To: Kady, Thomas[Kady.Thomas@epa.gov]
From: Egan, Robert
Sent: Wed 5/3/2017 7:25:25 PM
Subject: FW: Source data answer from Bristol/S2C2- EPA-Tribe Tracking Matrix 2B Tribal comments submitted and incorporated- Model #3 Groundwater comments
image003.wmz
image005.wmz
image013.wmz
image020.wmz

Thank you for the report entitled Supplemental Data Analysis and Data Visualization for the Tower Standard Site dated March 20, 2017 provided to the Tribe on April 28,2017. The Report includes the source data used, information on how the visualization was created, QA/QC information, and reference to applicable confidence bound factors. This report certainly expedites the review of the model files provided on April 3, 2017. I found the report useful to 4dm model review. Because of the pressing monitoring well placement discussions, two of the six 4dm files were prioritized for review.

Data Visualization #3:

HRSC_CSM_Direct Sensing.4dm - slide 9

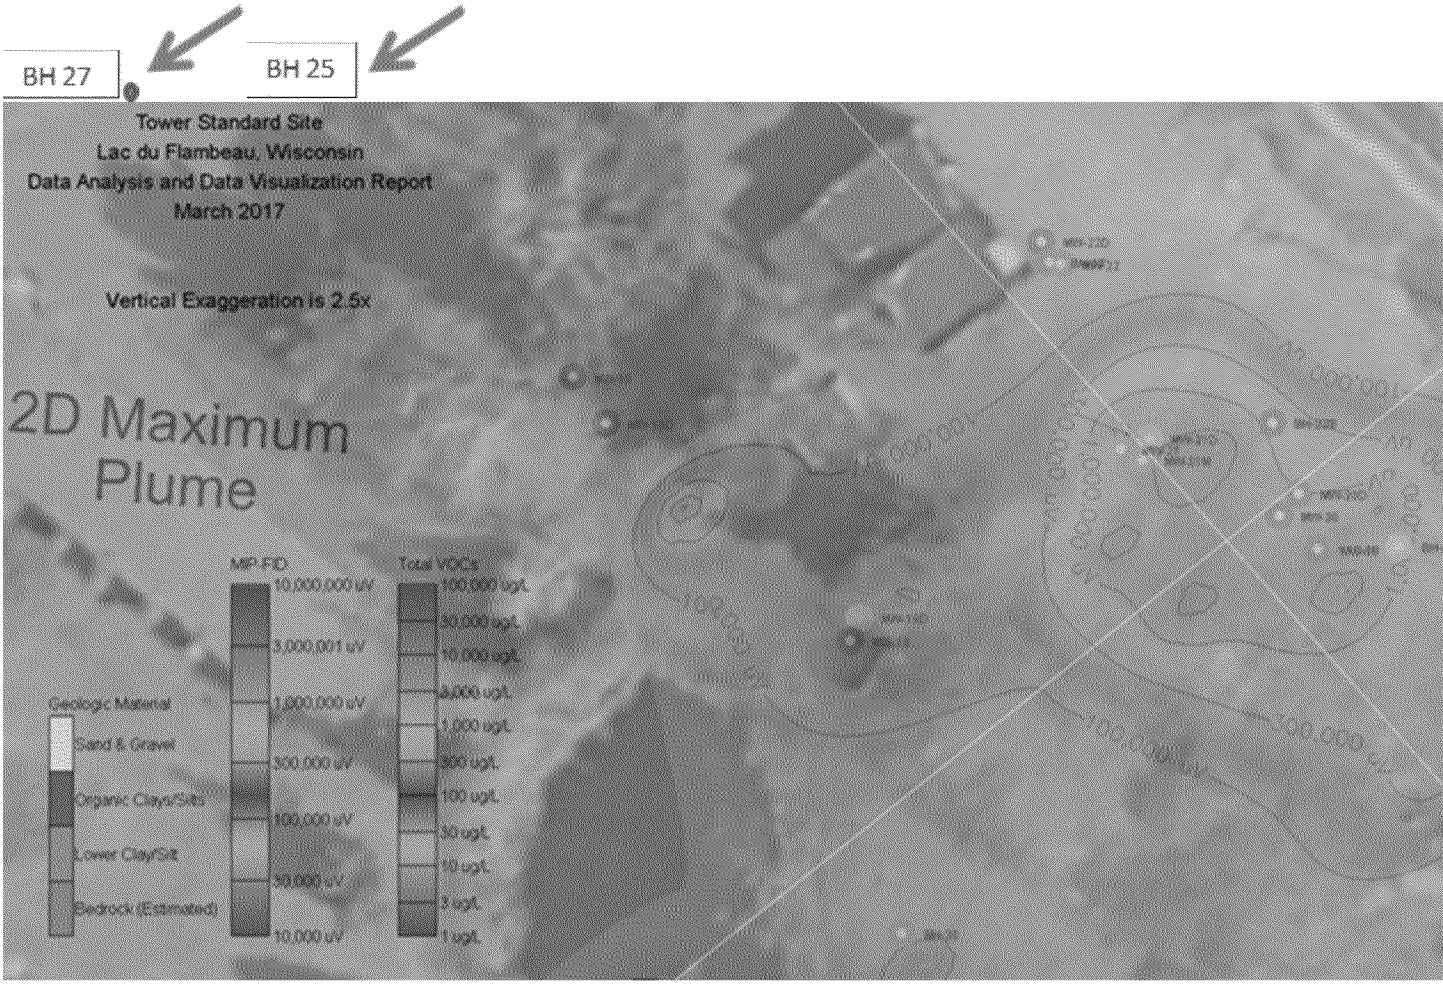
Control Points Skew Representation to the East

East Control Points:

The represented plume extends further east and north than data supports. This may be from the data addition of two control points, CP01 and CP02, located north and south of VAS 04 (based on coordinates- the control points do not appear on any map). The additional data points include 24 feet of MIP-PID response 10,000 uv.

This extends the represented contamination well east of documented directly measured clean BH25. BH25 shows No detection for PID screening, no detection for soil samples, and no detection for groundwater. Similarly, BH 27 provides documented clean conditions, but the represented plume extends north and east of this location.
